# UNITED STATES PATENT AND TRADEMARK OFFICE

APPLICATION NO.	FILING DATE	FIRST NAMED INVENTOR	ATTORNEY DOCKET NO.	CONFIRMATION NO.
10/029,394	12/28/2001	Jum Soo Kim	054216-5016	2075

## Office Action Summary

**DETAILED ACTION**

*FIG. 2B**FIG. 2C**FIG. 2D*

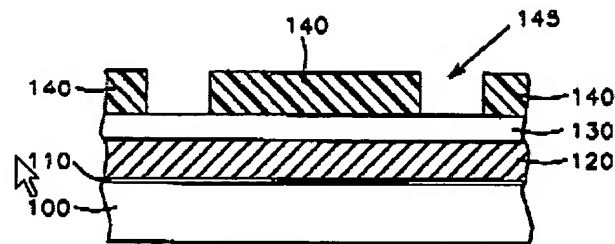
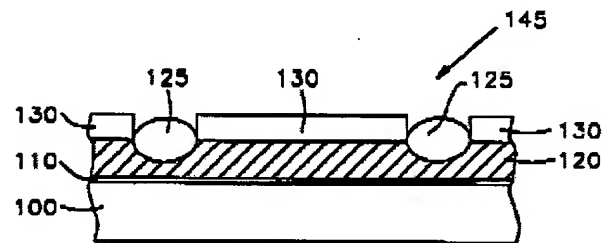
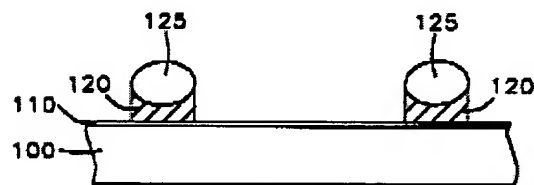
forming a device isolation film in a give region on a semiconductor substrate **100** to define an active region and a device isolation region; defining the active region into a cell region and a peripheral circuit region by a given process; forming a tunnel oxide film **110** and a first polysilicon film **120** on the entire circuit and then patterning the tunnel oxide film and the first polysilicon film so that the tunnel oxide film and the first polysilicon film remain in a give region of

the cell region, thus defining a floating gate (pages 3-4, paragraphs [0035]-[0036] and FIGS. 2B-D);

*FIG. 2E**FIG. 2F**FIG. 2G*

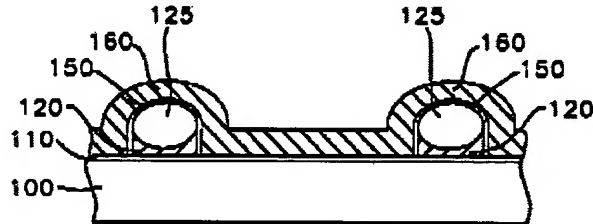
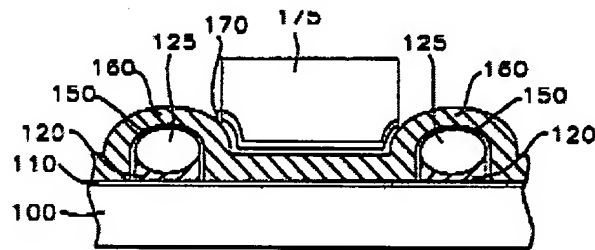
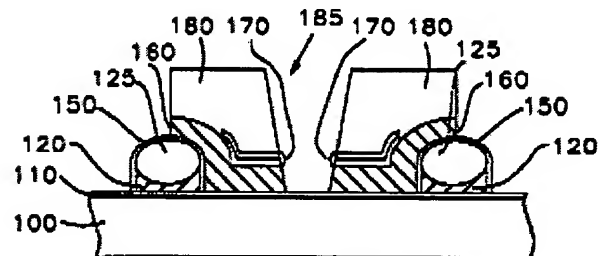
forming on the entire structure an insulating film 170 including an oxide film and a nitride film (page 4, paragraph [0039]) and forming a second polysilicon film 160 on the insulating film; patterning the second polysilicon film and the insulating film so that they remain in a given region of the cell region and the peripheral circuit region, thus forming a control gate on the insulating film covering the floating gate in the cell region and a gate on the insulating film

covering a surface of the substrate in the peripheral circuit region (page 4, paragraphs [0038]-[0039] and FIGS. 2E-G); and

**FIG. 2H**

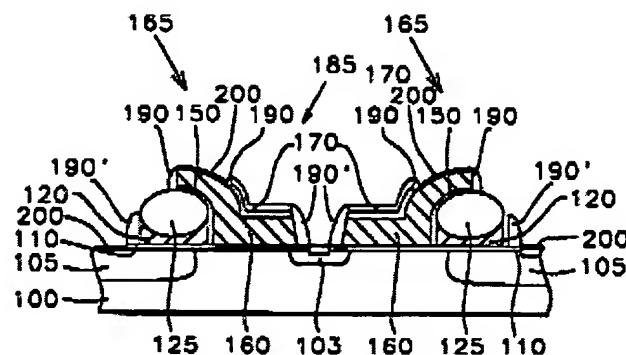
performing an impurity ion implantation process for a give region of the semiconductor substrate to form a source region 105 and a drain region 103, so that a flash memory cell is formed in the cell region, and a code address memory cell is formed in the peripheral circuit region (page 4, paragraph [0041] and FIG. 2H).

**FIG. 2**

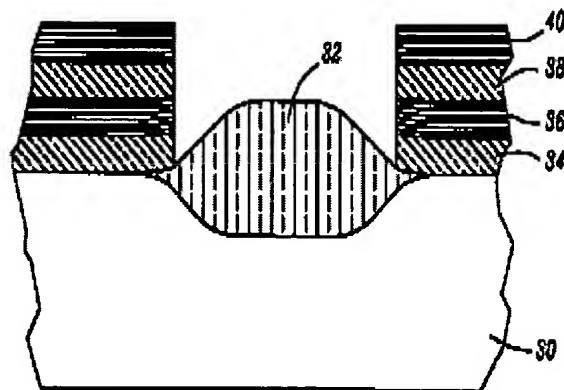
In re claim 11, Ma et al. (U.S. Patent 5,981,403) provide evidence that the process of forming an insulating film by stacking a first oxide film, a first nitride film, a second oxide film and a second nitride film is well-known to one of ordinary skill in the art at the time of the invention was made. Ma et al. disclose an ONON structure includes a first oxide layer 34, a first nitride layer multilayer region 36, a second oxide layer 38 and a second nitride multilayer region 40 (col. 2, lines 12-16 and FIGS. 1-3).
